From: Chris Strupp <Chris.Strupp@ohm-advisors.com>
Sent: Wednesday, September 21, 2022 4:08 PM
To: Water Permits; Brad Harris; Wade Murphy
Cc: Dudley Fox; Jason Griffin; Bruce Parola; timoud@bellsouth.net; Clay Underdown; buckoud@yahoo.com; jasonfarmertn@gmail.com; Landbased Systems; Angela Jones; Timothy Hill; Robert Odette; Jennifer Innes; Jason Dees
Subject: [EXTERNAL] RE: Graywood Farms North State Operating Permit Application_SOP-22022_Ocoee Utility District
Attachments: Graywood Farms North SOP Application Rev. 1 20220921_s.pdf

Brad, Wade: Please find attached the updated SOP-22022 Application for your review and consideration. The following changes have been made following our meeting last week Thursday:

RE: Bradley County, Tennessee
State Operating Permit – Graywood Farms North
Bradley County, TN
OHM Project Number: 0563220150

APPLICATION FOR A STATE OPERATION PERMIT (SOP)

TITLE
TREATMENT &
DRIP DISPERSAL
SITE PLAN
DRAWING NO.
C7.0

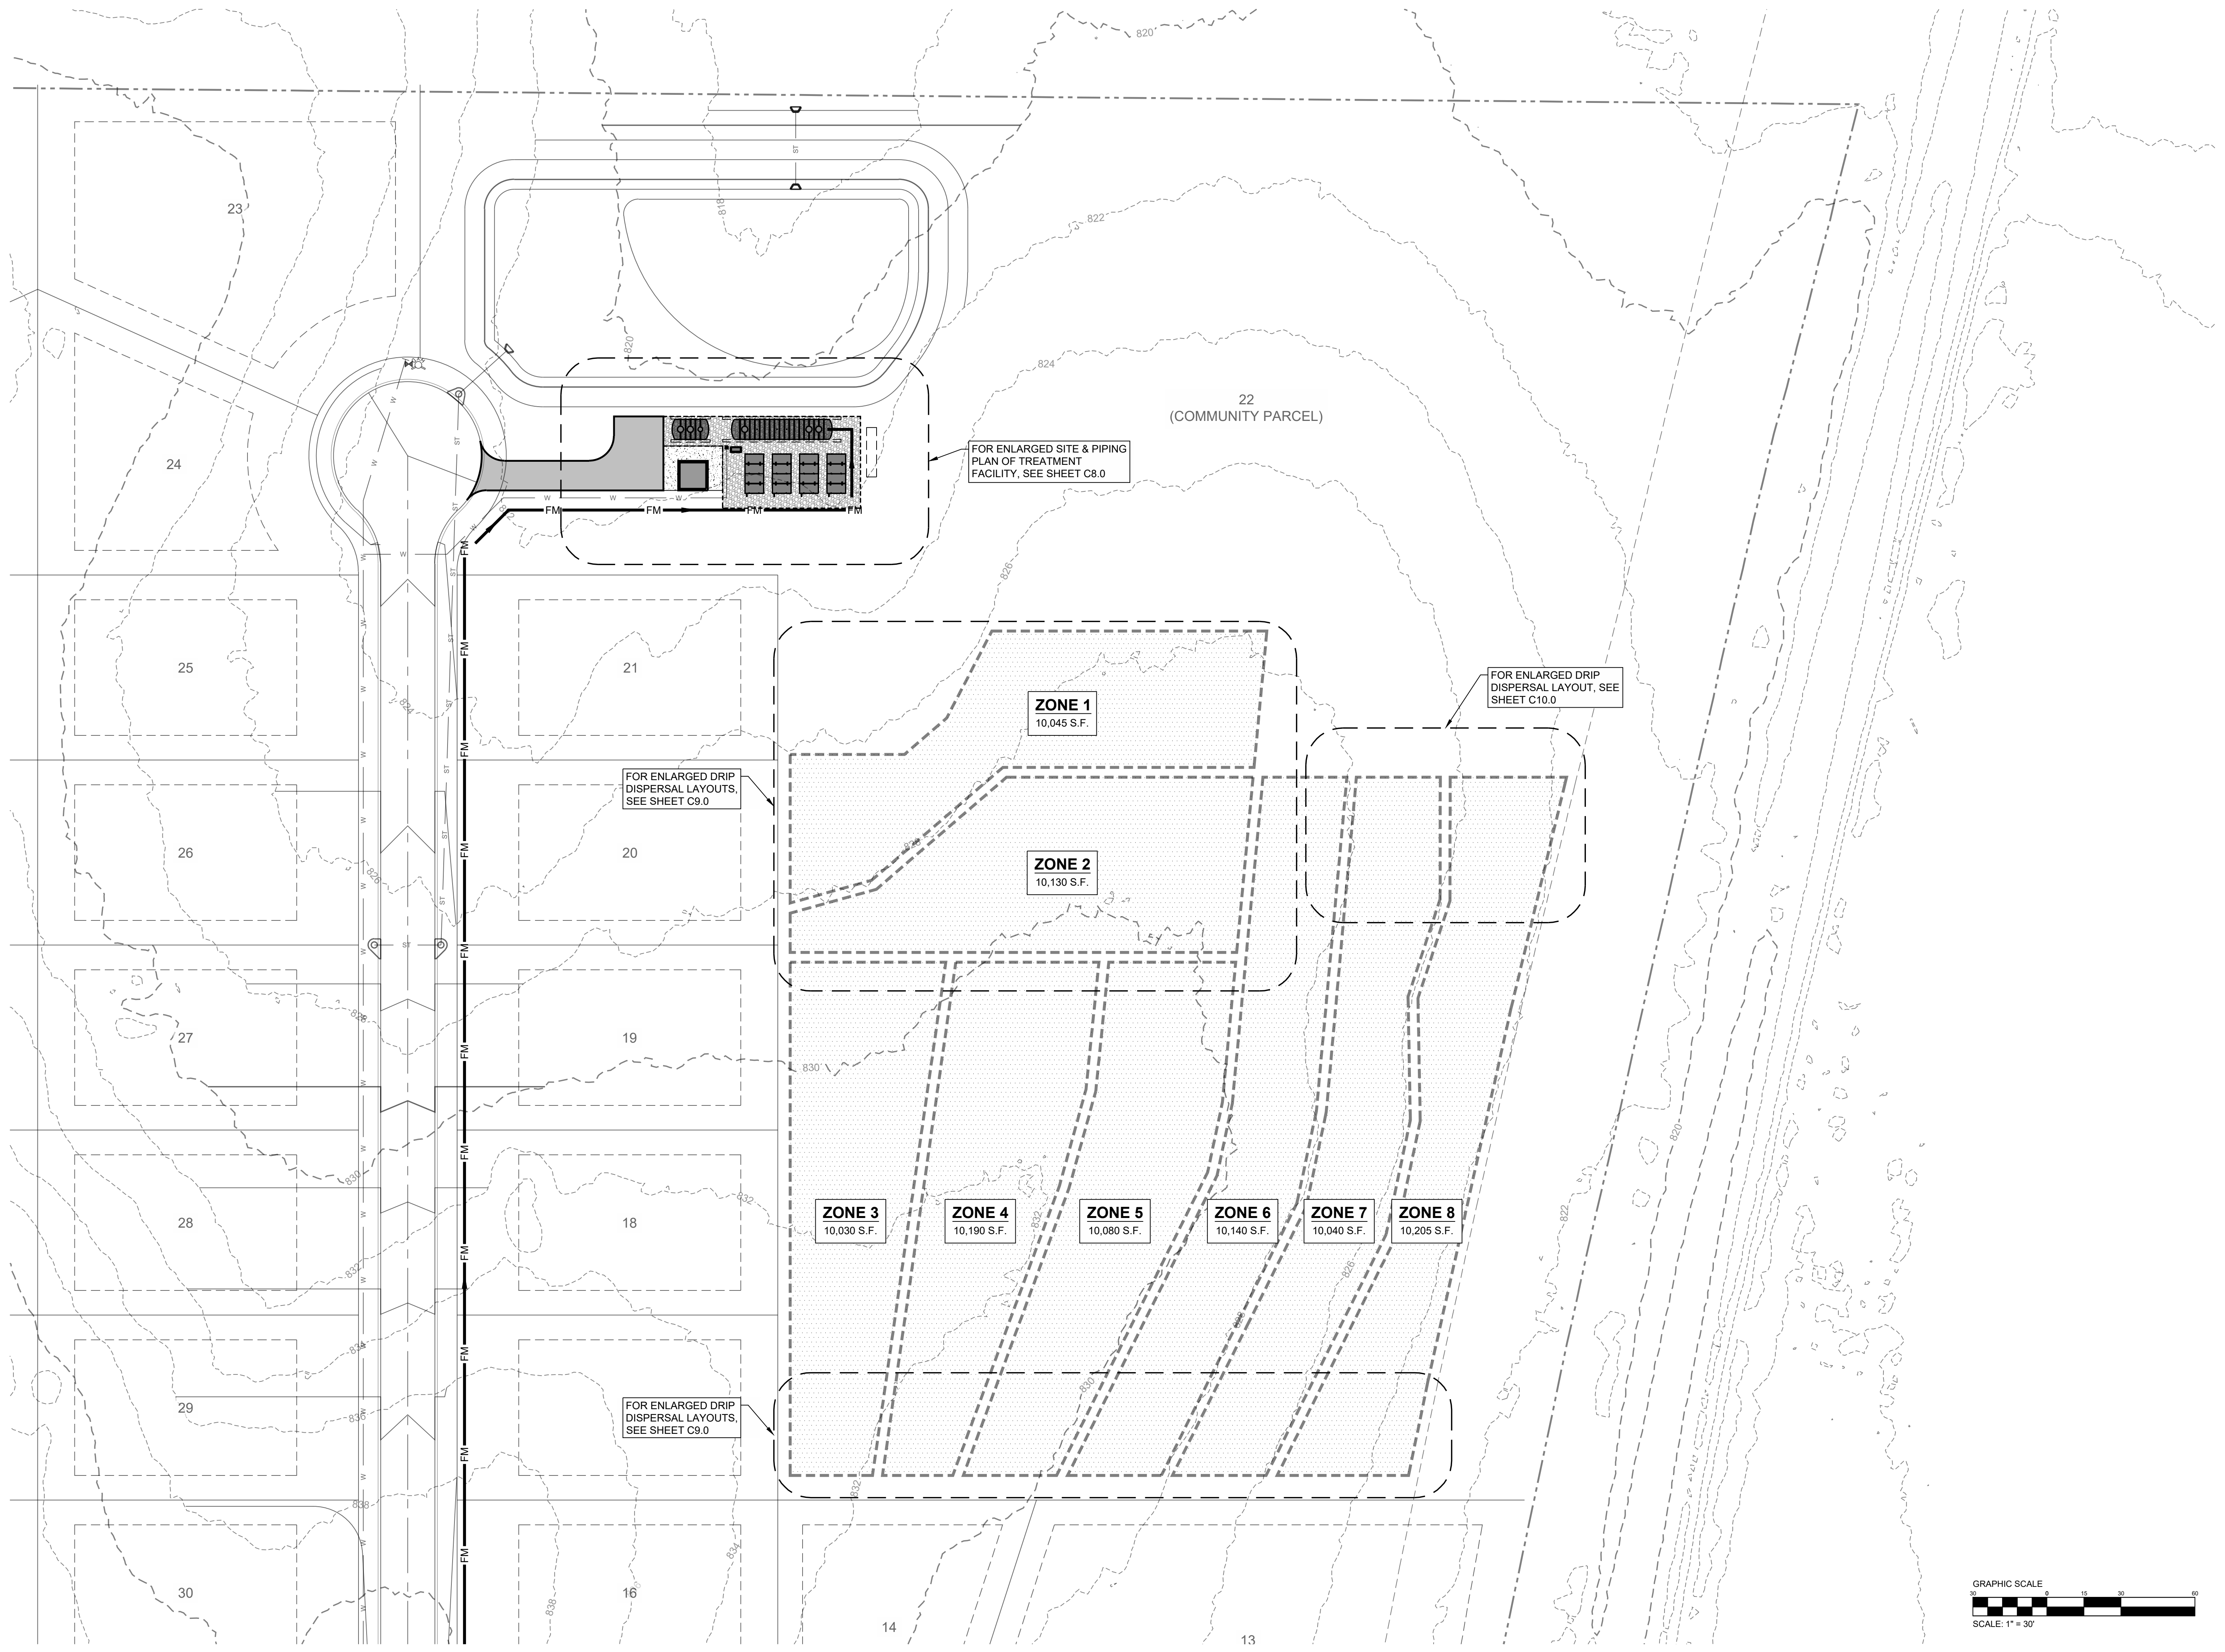
1. 10 drip zones (an increase from original 8 drip zones) are proposed with a total of approximately 100,000 SF of drip area. A revised WWTP and drip zone layout is provided in the figures tab. The peak system design flow remains at 20,000 GPD resulting in a drip loading rate of 0.20 GPD/SF. Page 4 of the SOP application was updated.
2. The average system design flow has been updated to 14,000 GPD (up from 12,000 GPD) to reflect the approximate 250 GPD/ERU. This results in an average drip loading rate of 0.14 GPD/SF with 10 drip zones and a total of approximately 100,000 SF of drip area.
3. The PDF in the figures tab has been updated to reflect additional design details.
